Product Change Notification

Change Notification #: 114839 - 00
Change Title: Intel® Omni-Path Edge Switch 100 Series 24 Port Managed Forward 2 PSU 100SWE24QF2, Intel® Omni-Path Edge Switch 100 Series 24 Port Forward 2 PSU 100SWE24UF2, Intel® Omni-Path Edge Switch 100 Series 48 Port Managed Reverse 2 PSU 100SWE48QR2, Intel® Omni-Path Edge Switch 100 Series 48 Port Reverse 2 PSU 100SWE48UR2, Intel® Omni-Path Edge Switch 100 Series 48 Port Managed Forward 1 PSU 100SWE48QF1, Intel® Omni-Path Edge Switch 100 Series 48 Port Forward 1 PSU 100SWE48UF1, Intel® Omni-Path Edge Switch 100 Series 24 Port Forward 1 PSU 100SWE24UF1, Intel® Omni-Path Edge Switch 100 Series 48 Port Managed Forward 2 PSU 100SWE48QF2, Intel® Omni-Path Edge Switch 100 Series 48 Port Forward 2 PSU 100SWE48UF2,

Locking Hat Rail Screw Update

Date of Publication: September 2, 2016

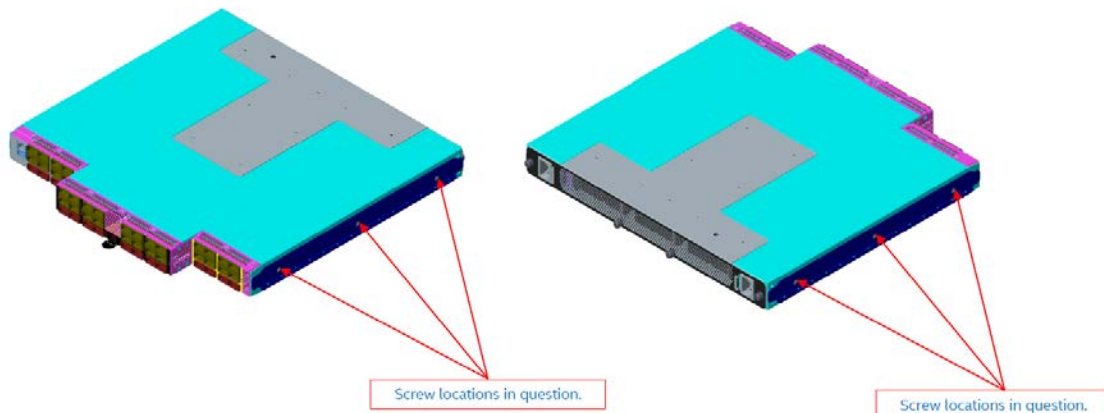
The Omni-Path Edge Switch will change the hat rail screws from standard screws to locking screws to prevent back out during vibration.

Screws used to secure Omni-Path Edge Switch 100 Series hat rails to each side of the switch chassis are susceptible to backing out during extreme in-rack vibrations. To address this issue, standard screws are being replaced with locking screws.

H51785-117 screws used to secure Omni-Path Edge Switch 100 Series hat rails to each side of the switch chassis are replaced with J32098-022 locking screws. The following drawings show the positions of the six screws changed as part of this PCN:
